Council's Response to NT Planning Scheme Amendment PA 2008/0373

I refer to the proposed NT Planning Scheme Amendment PA2008/0373 to amend Clause 6.3 Building Heights in Central Darwin. The proposal was considered at Council's Town Planning Committee of 1 July 2009.

Building Heights within Central Darwin

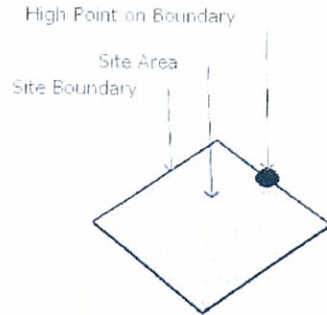
- There is concern that the proposed controls could promote monotonous development in the Darwin CBD.
- While Council supports the concept of a 'civic precinct' it is concerned as landowner that the Civic Centre and adjacent land shown on the diagram to clause 6.3.1 is excluded from the proposed amendment to building heights in the Darwin CB zone;

DIAGRAM TO CLAUSE 6.3.2

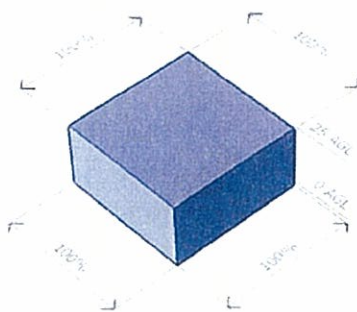
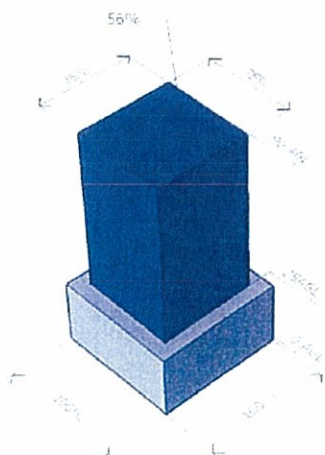
- Highest buildings should be located in the centre of the Darwin CBD to protect views and breezeways rather than a blanket 90 metre height limit across the whole of the Darwin CBD;
- The development of 100% of sites up to 25 metres in height could mean no setback for pedestrians at ground level and could result in bulky podium development throughout the CBD. Larger sites in particular need detailed study so that pedestrian areas can be created adjacent to footpaths.
- The controls may encourage box like development if developers only develop to 25 metres with a 100% site coverage;
- The building and volumetric controls could encourage site amalgamations and result in the loss of the low scale character of parts of the Darwin CBD. Future development controls should not erode the small scale activities and buildings that contribute to the core of Darwin's identity;

- The volumetric controls involving building setbacks at the nominated height will mean that buildings will not produce the same amount of floor space under current height controls, without prior consultation with the landowner, Darwin City Council;
